## MEETING MINUTES

Project Name: UW-La Crosse New Residence Halls  
DSF No. 08B3M  
EUA Project Number: 708190-01  
Meeting Date: December 08, 2008 at Cartwright Center – 12:30 p.m.

II. First Floor Discussion:

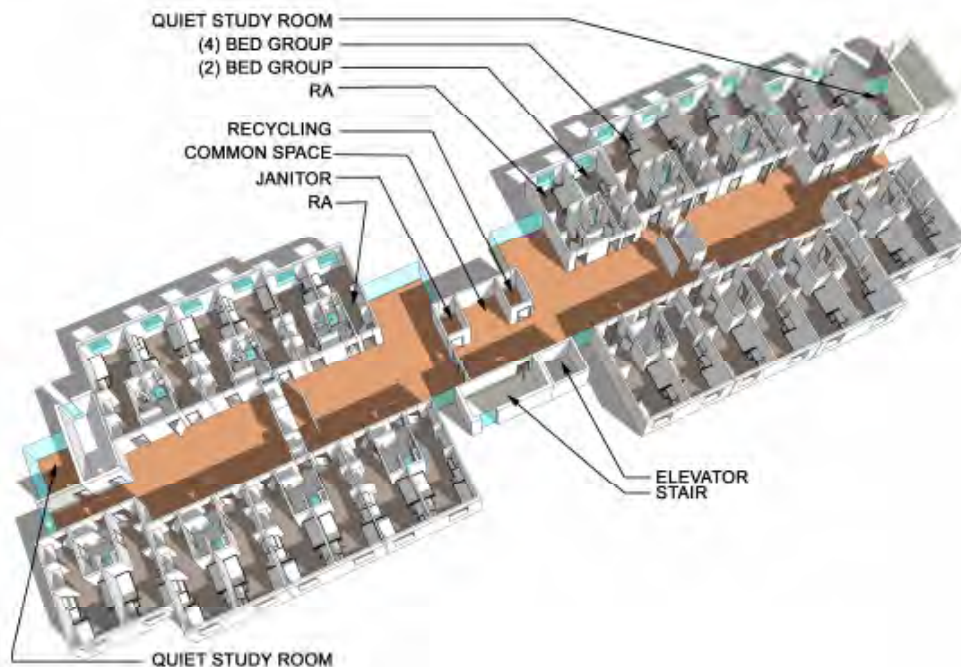
- A. The Residence Life Office area needs to have its own identity and a readily identifiable entrance.
  - 1. On the current layout it is pulled out to the northeast corner of the building.

- 2. It was brought up that a northeast facing entry is not the greatest for Wisconsin winters.
- B. The Res Life Office shows 8 spaces assigned to the Assistant Director function.

- 1. There are currently 6 Assistant Director positions
  - 2. That will leave 2 office spaces available for meetings and/or future growth.
- C. The Director and Assistant Directors offices are shown as all in a row.

- 1. This layout is more efficient than arrayed around a reception area or entrance.
- D. Work and Copy spaces are centrally located
- E. A discussion was had about Graduate Assistant offices

- 1. The location of these is not as crucial as other components.
  - 2. It was decided that (2) rooms with (2) grad students in each room was preferred over (1) room with (4) grad students.

- F. Could we flip the kitchen and game room spaces?
  - 1. Yes, that is likely to happen in some form.
  - 2. EUA reminded everyone that the building is not fully designed so the spaces are likely to change shape and/or location at some point during the design process.

V. Unit Plan Discussion:

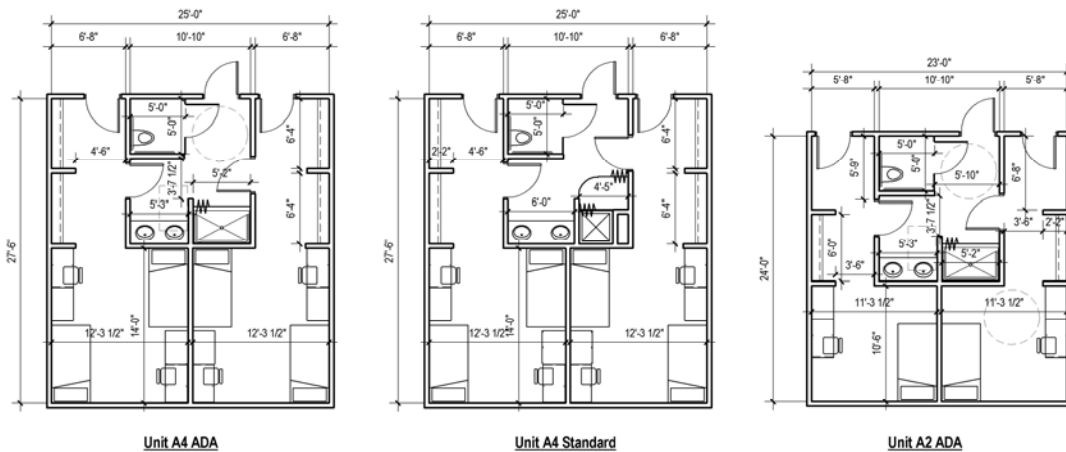
- A. The standard shower size was discussed:
  1. 3'x3' is shown, vs. what it would take to have a 3'x4' stall
  2. Reuter Hall has 3'x4' stalls per UW La Crosse
  3. EUA will rework non-ADA bathroom to fit in 3'x4' shower if possible
  4. UW La Crosse would like as few roll in showers as possible.
  5. Type B units will still require accessibility at entry, to rooms, and within bathrooms for visitors
  6. The fact that the shower faces the door should not be a problem because the door is not an exit door and will remain closed and locked except for "escape" and housekeeping purposes.
- B. It was noted by EUA that the room sizes are tight and may limit furniture layouts.
- C. RA units will be one of the single units in the 2-bed ADA unit of each house.
